**CITY OF KELOWNA  
MEMORANDUM**

**APPLICATION NO.** Z08-0112      **APPLICANT:** Rick and Karen Dilullo

**AT:** 2315 Brentwood Road      **OWNER:** Karen Dilullo

**PURPOSE:** TO REZONE FROM THE A1 AGRICULTURE 1 ZONE TO THE A1(S) AGRICULTURE 1 WITH A SECONDARY SUITE ZONE TO CONSTRUCT A SECONDARY SUITE IN AN ACCESSORY BUILDING

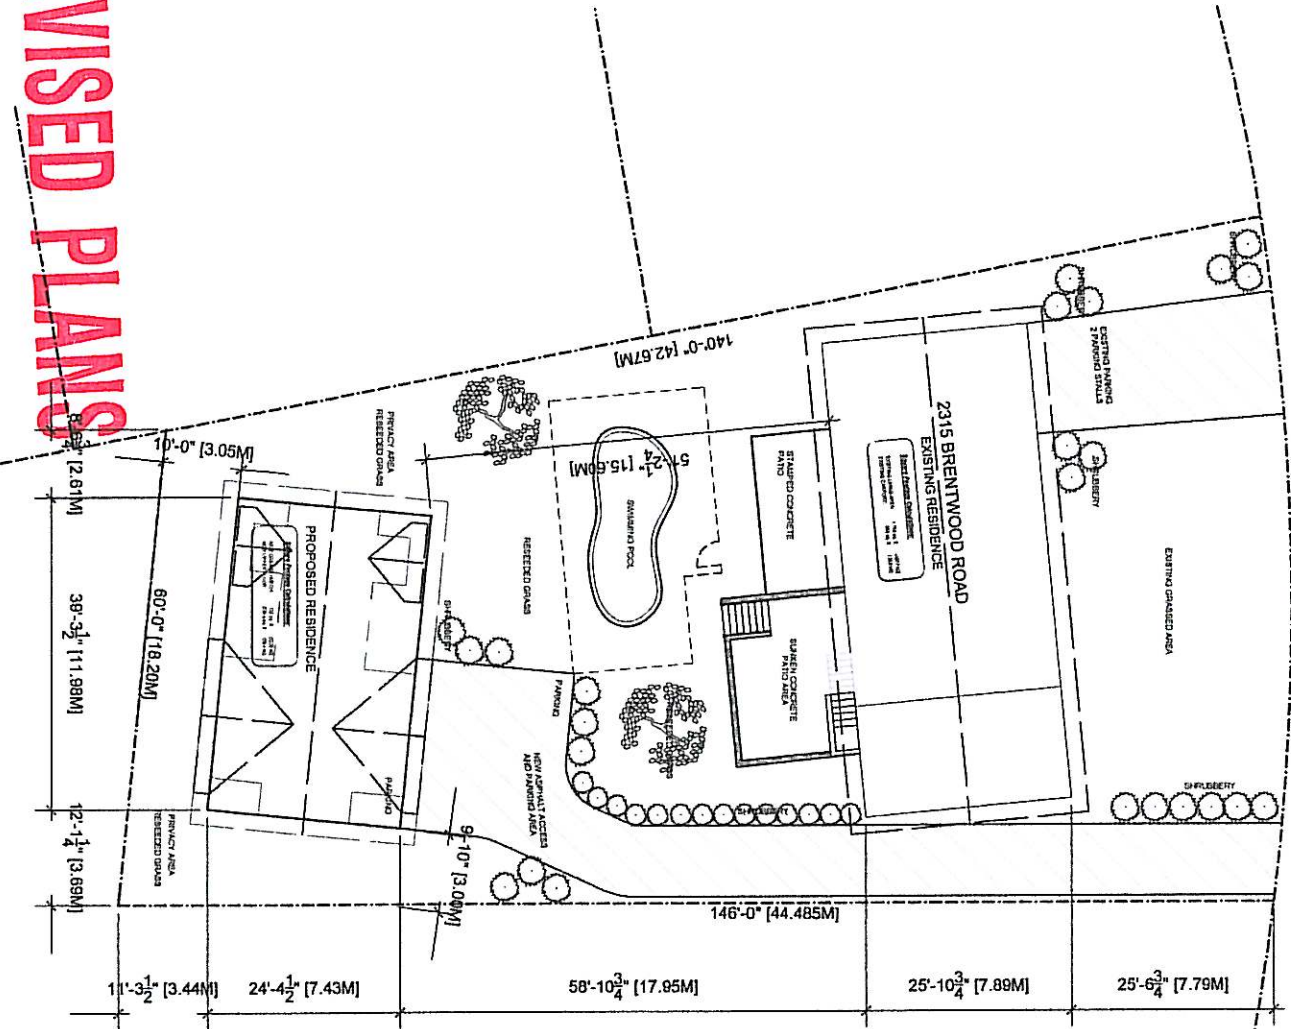
An unobstructed and easily distinguishable firefighter access path, of 1100 mm, from the street to the back of the property line and to the secondary suite main entrance is required.

Maintain, in all seasons, a minimum access width of 1100 mm for firefighter access to the rear of the property and to the secondary suite main entrance.

Fire fighter access from the front of the property to the back building(s)/property line is not to be impeded at anytime.

If a fence is ever constructed between the dwellings an 1100 mm, clear width, gate is required. Any gate is to open with out special knowledge.

Sufficient on-site Parking is provided. Applicant is to confirm that the access to the suite is a minimum of 3.0m. wide as per Zoning Bylaw.
